PROPOSED TECHNICAL SPECIFICATION CHANGES
REGARDING PRESSURE-TEMPERATURE LIMITS

(JPTS-89-024)

JAMES A. FITZPATRICK NUCLEAR POWER PLANT

**SAFETY EVALUATION FOR PROPOSED
TECHNICAL SPECIFICATION CHANGES
REGARDING PRESSURE-TEMPERATURE LIMITS**

Figure 3.6-1 Part 1 Reactor Vessel Pressure-Temperature Limits Through 12 EFY

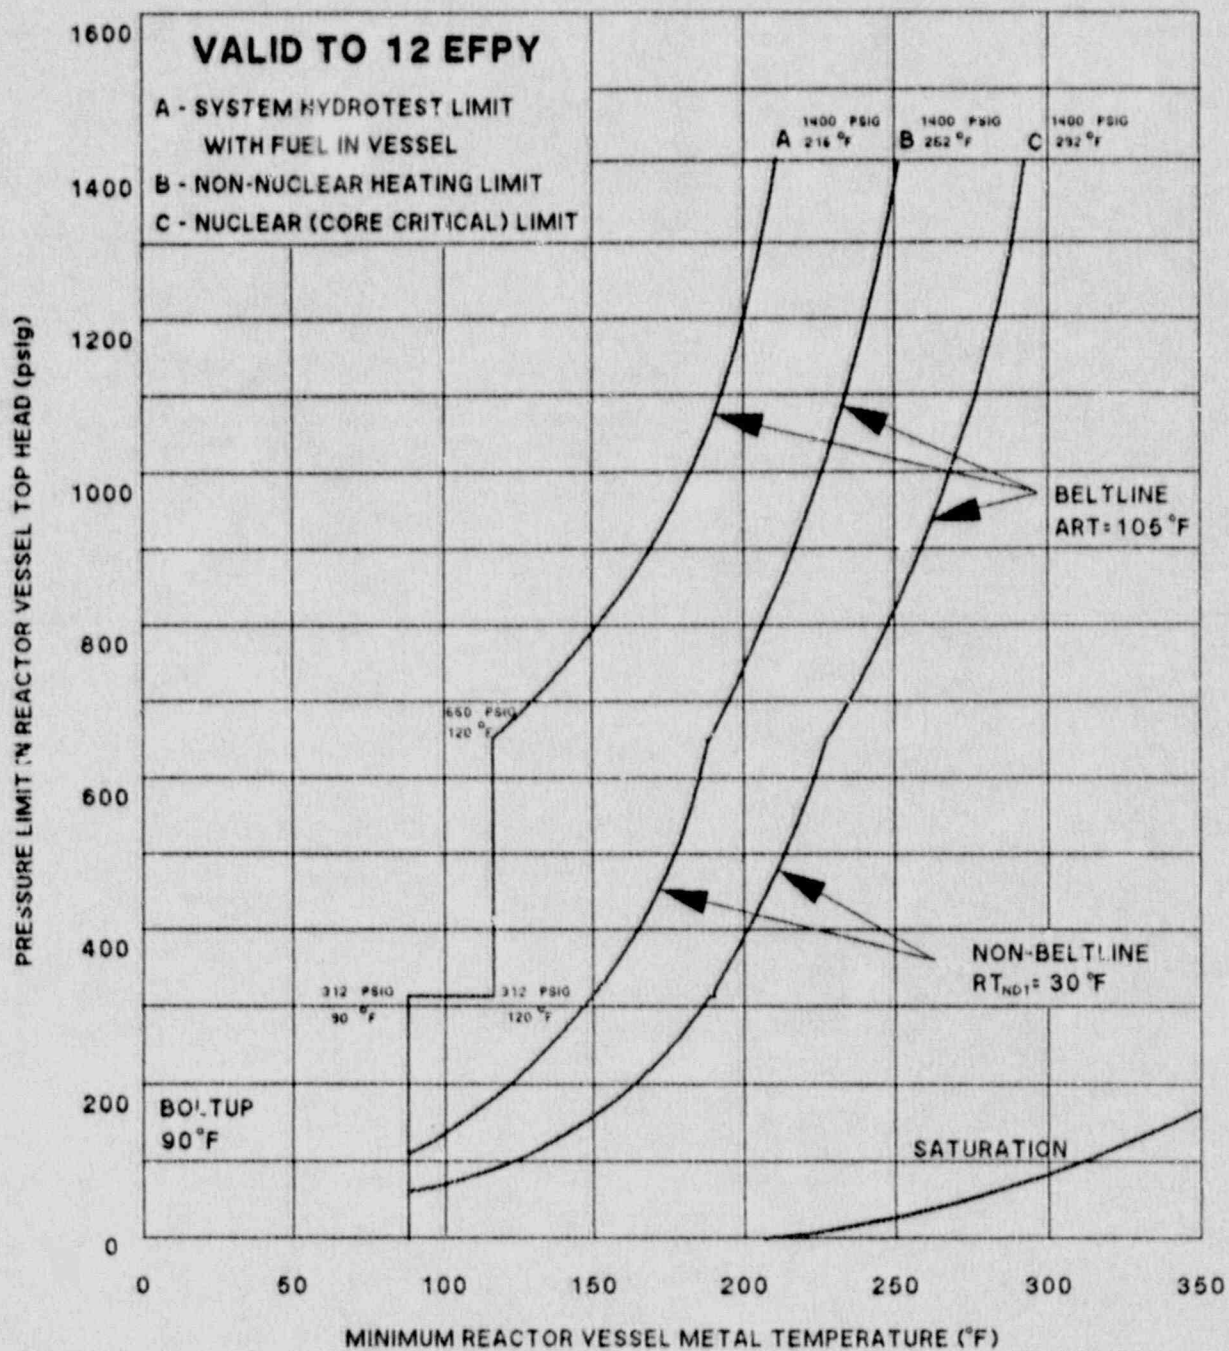
Figure 3.6-1 Part 1, "Reactor Vessel Pressure - Temperature Limits Through 12 EFPY," on page 163

New beltline Pressure-Temperature curves were developed for operation to 12, 14, and 16 Effective Full Power Years (EFPY). The non-beltline region curves (recirculation inlet nozzles and head flanges) are not affected by the changes to RT_{NDT} shift associated with Regulatory Guide 1.99, Revision 2.

The beltline curves apply to the vessel plates and welds and are limiting above 500 psig. For example, at a 1000 psig on the leak test curve, the required test temperature is 192°F for 16 EFPY compared to the current limitation of 157°F.

The first technical specification change lowers the P-T curves (i.e., a higher temperature is required for a given pressure) which in turn "narrows" the reactor coolant system operating window and lengthens the time required for hydrostatic testing. This change is consistent with Generic Letter 88-11 to ensure a conservative margin to non-ductile failure.

Figure 3.6-1 Part 2 Reactor Vessel Pressure-Temperature Limits Through 14 EFPY

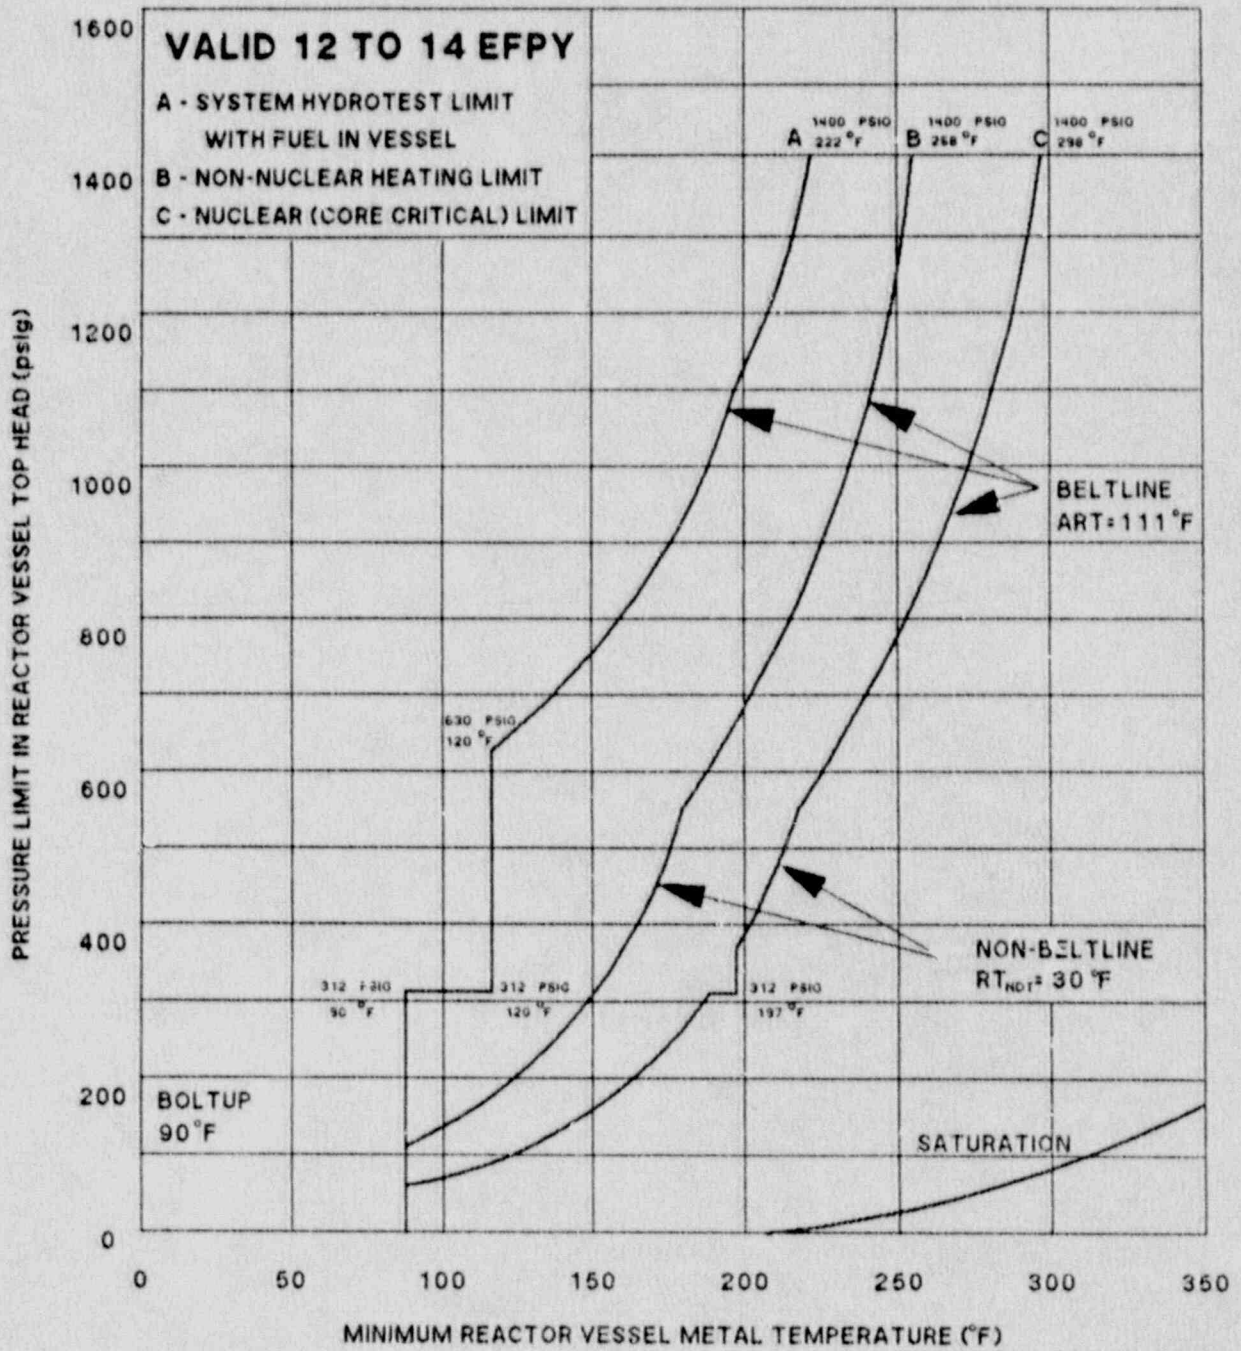
Figure 3.6-1 Part 2, "Reactor Vessel Pressure - Temperature Limits Through 14 EFPY," on page 163a

The new P-T curves were developed for three service periods: ≤ 12 EFPYs, ≤ 14 EFPYs, and ≤ 16 EFPYs. The use of three curves instead of one lessens operational impacts by phasing the increases in minimum temperature over three distinct service periods. Each set of P-T curves is

Figure 3.6-1 Part 3 Reactor Vessel Pressure-Temperature Limits Through 16 EFY

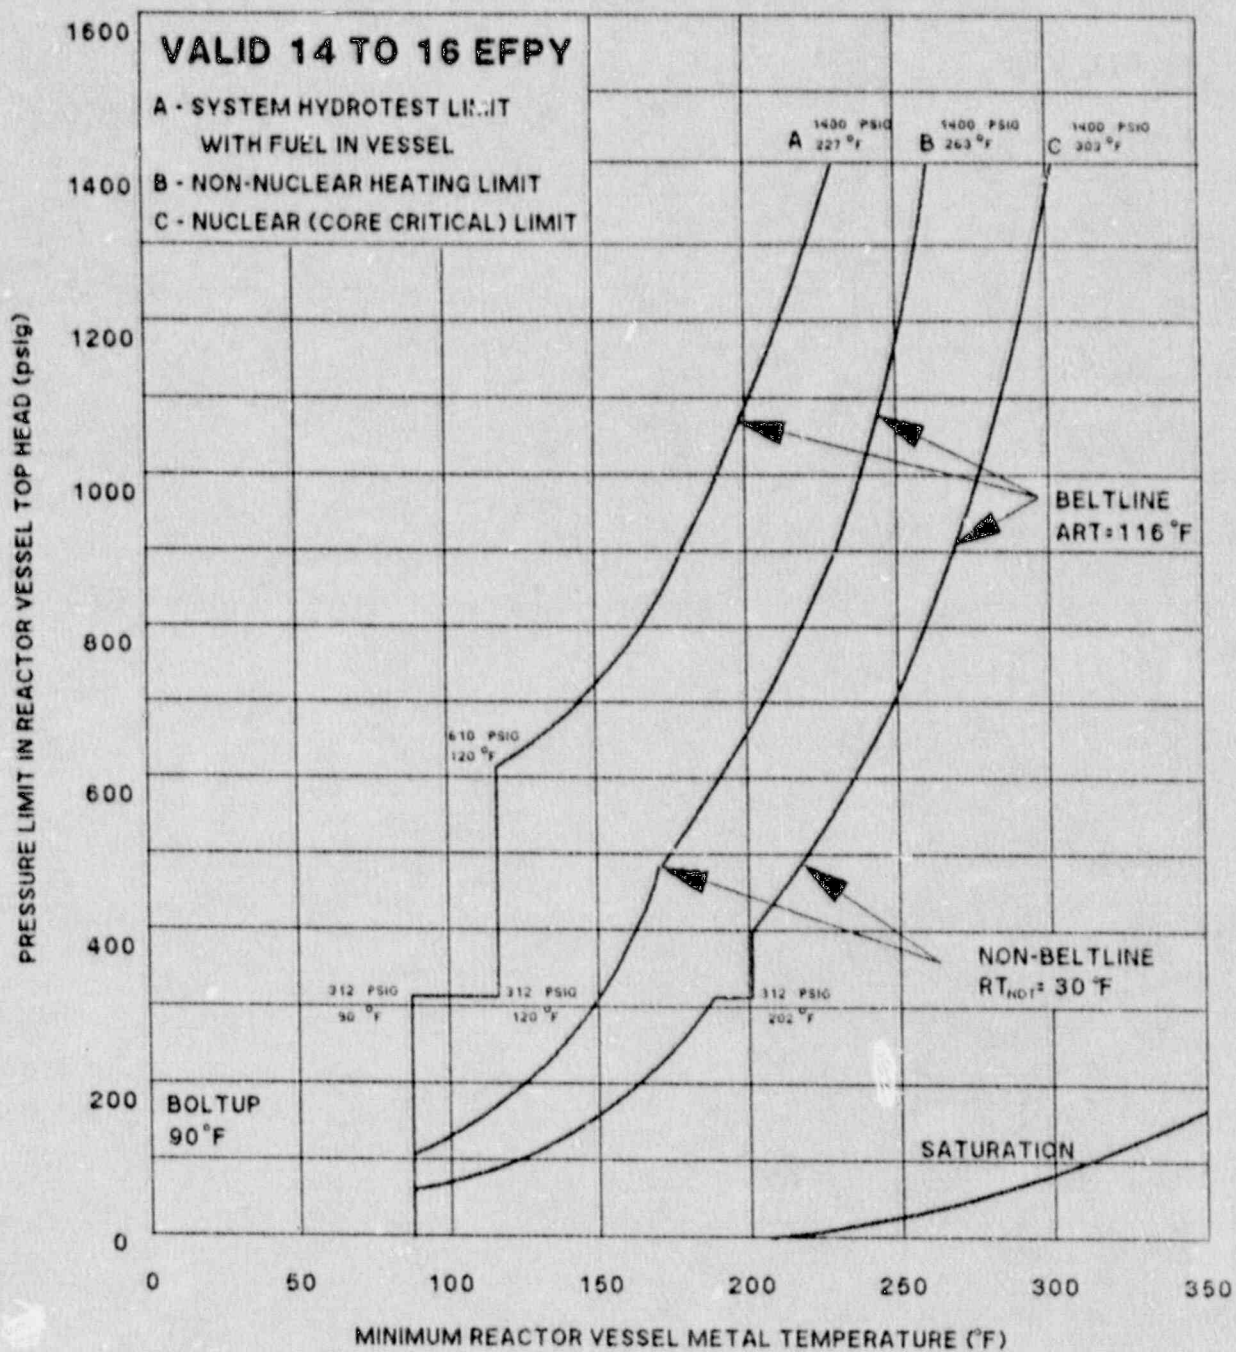
Figure 3.6-1 Part 3, "Reactor Vessel Pressure - Temperature Limits Through 16 EFPY," on page 163b
